TOWN OF LOS ALTOS HILLS  
Staff Report to the Planning Commission

November 6, 2014

SUBJECT:    CONDITIONAL DEVELOPMENT PERMIT AND SETBACK VARIANCE  
              FOR AN ADDITION AND REMOVAL OF A HERITAGE OAK TREE;  
              LANDS OF MATHUR; 27299 BYRNE PARK LANE; FILE #140-14-ZP-SD-  
              CDP-VAR

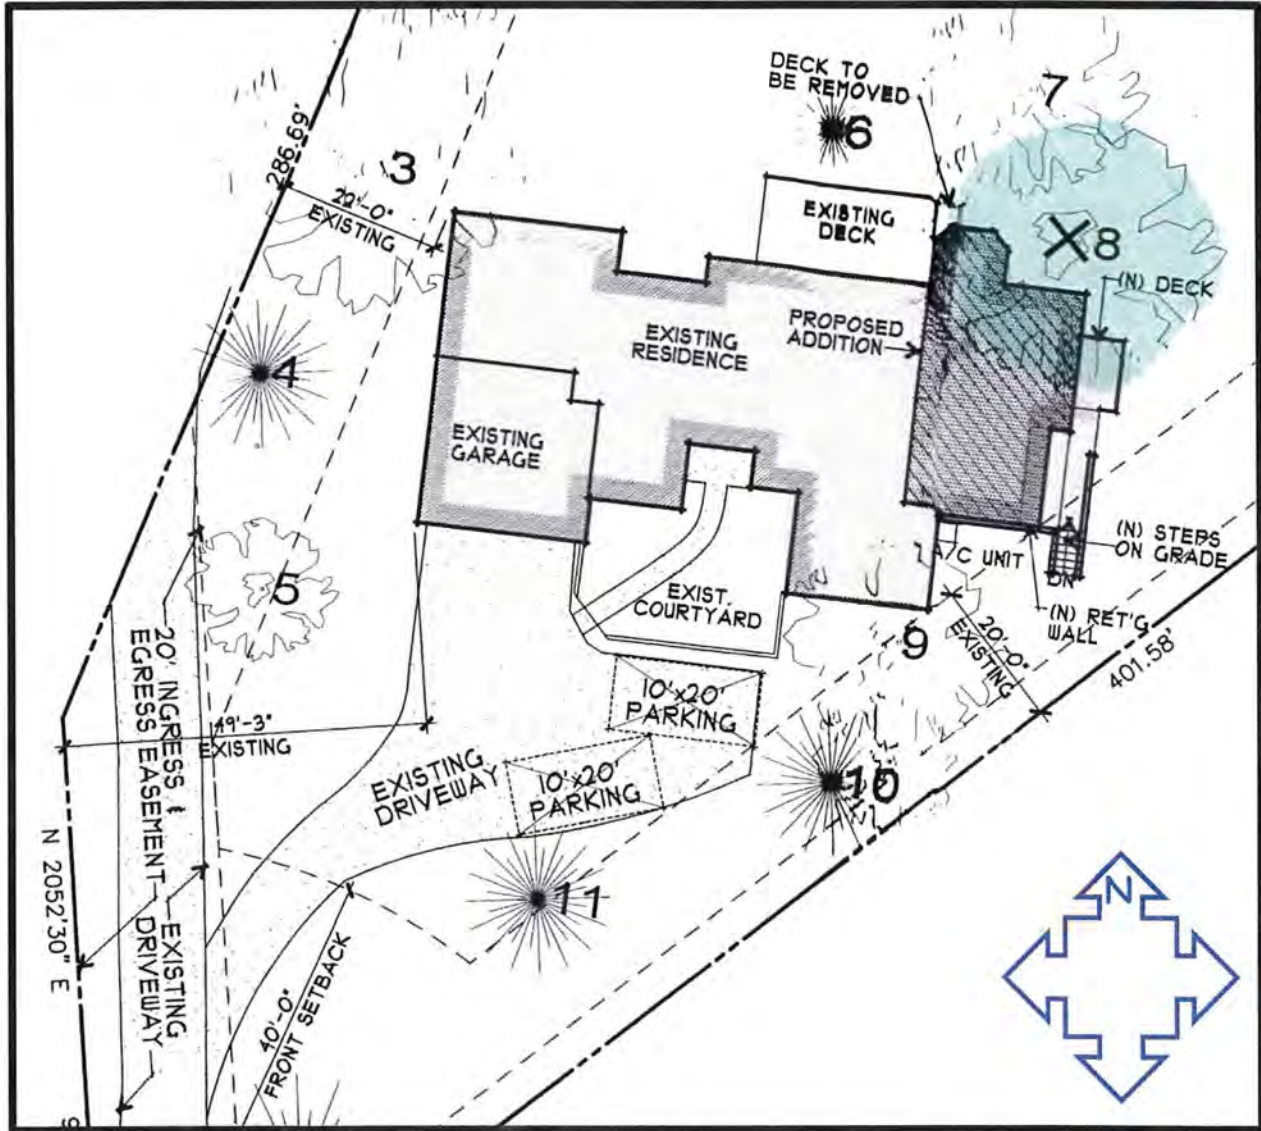
A portion of the Site Plan in the construction plan set I received is shown above. I have highlighted the subject oak, which is labeled as tree #8. Based upon the plans it appears that the North side of the addition is about 6 feet from the trunk, and the west portion is 8 feet. These distances are approximate however, and may actually be a bit farther because the tree is on a slope below the existing house. Excavation for the addition however, can be expected to extend a few feet beyond the actual wall of the addition. So, if the tree may remain I think it would be a good idea to actually survey the location of the addition (and also note any necessary over-excavation beyond the addition) relative to this tree.

Regarding the oak's canopy, it is already fairly high now due to past pruning for the existing house, and a general thinning of the canopy. But the new addition will be close to the tree, so if the oak does remain story posts will be helpful in understanding the actual impact on the canopy.

- 1) **Decide either to attempt to save or the tree, or to remove the tree.**
- 2) **If the tree may be saved**, accurately locate improvements in the field, relative to the trunk and the canopy. Use story posts for the canopy.

- a) A distance of 8 linear feet is recommended as a minimum no soil disturbance zone from the edge of the trunk of this tree. If this distance cannot be achieved, I would lean toward removing the tree. This is the 5xDBH distance for this tree, which will experience soil disturbance on two sides of its trunk. It may be possible to squeeze down over-excavation margins in order to achieve this distance, or redesign the addition to move construction slightly farther from the tree.
